UNITED STATES PATENT AND TRADEMARK OFFICE

10/589,129

Office Action Summary	Application No. 10/589,129	Applicant(s) TAMURA ET AL.	
	Examiner MICHAEL CARTON	Art Unit 3748

DETAILED ACTION***Response to Arguments***

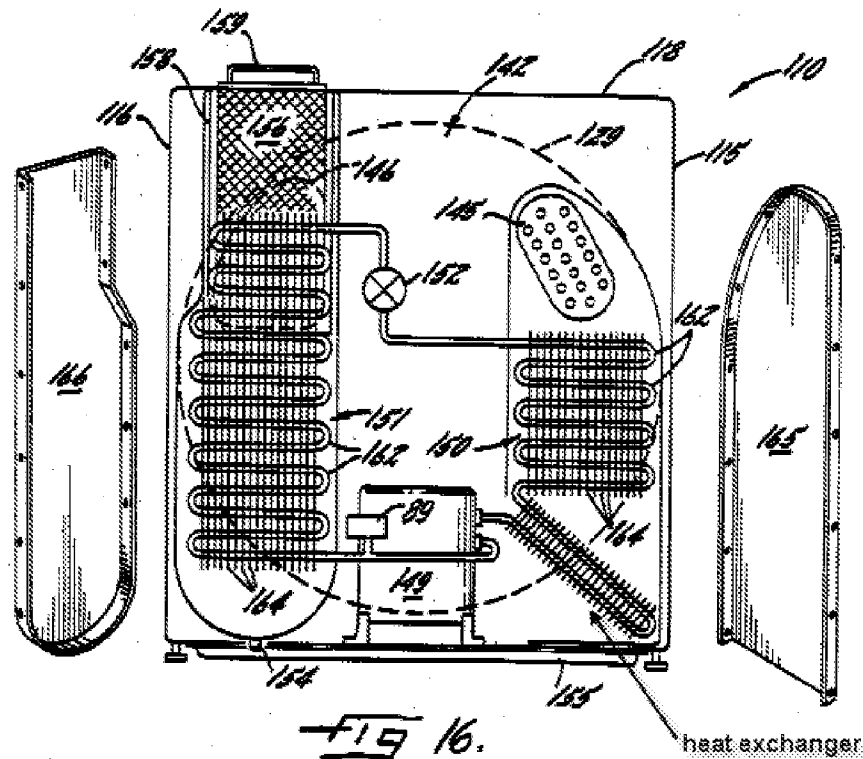
With respect to the argument concerning the third heat exchanger illustrated in fig 16 of Lanciaux, the examiner points to annotated fig 16 below wherein the 3rd, unnumbered heat exchanger is pointed out.

With respect to claim 1, Lanciaux discloses a compressor 149 (fig 15) for compressing a refrigerant; a circulation duct 145 (fig 15) for circulating drying air therein; a radiator 150 (fig 15), disposed inside said circulation duct (fig 16 and fig 15 disclose the radiator inside the duct), for condensing the refrigerant to heat the drying air (fig 17 and fig 18 disclose air with arrows, indicating air passing through condenser, evaporator and heat exchanger which clearly exchanges heat with the said devices); an evaporator 151 (fig 16), disposed inside said circulation duct, for evaporating the refrigerant to absorb heat from the drying air (fig 17 and fig 18 disclose air with arrows, indicating air passing through condenser, evaporator and heat exchanger which clearly exchanges heat with the said devices); a first throttle apparatus 152 (fig 15) for controlling the refrigerant pressure; a heat exchanger (see annotated fig 16 below indicating “heat exchanger”), disposed inside said circulation duct, for functioning as another radiator for condensing the refrigerant to heat the drying air or as another evaporator for evaporating the refrigerant to absorb heat from the drying air (annotated fig 15 above, in the response to arguments, indicates the air flow, and the heat exchanger assisting the other heat
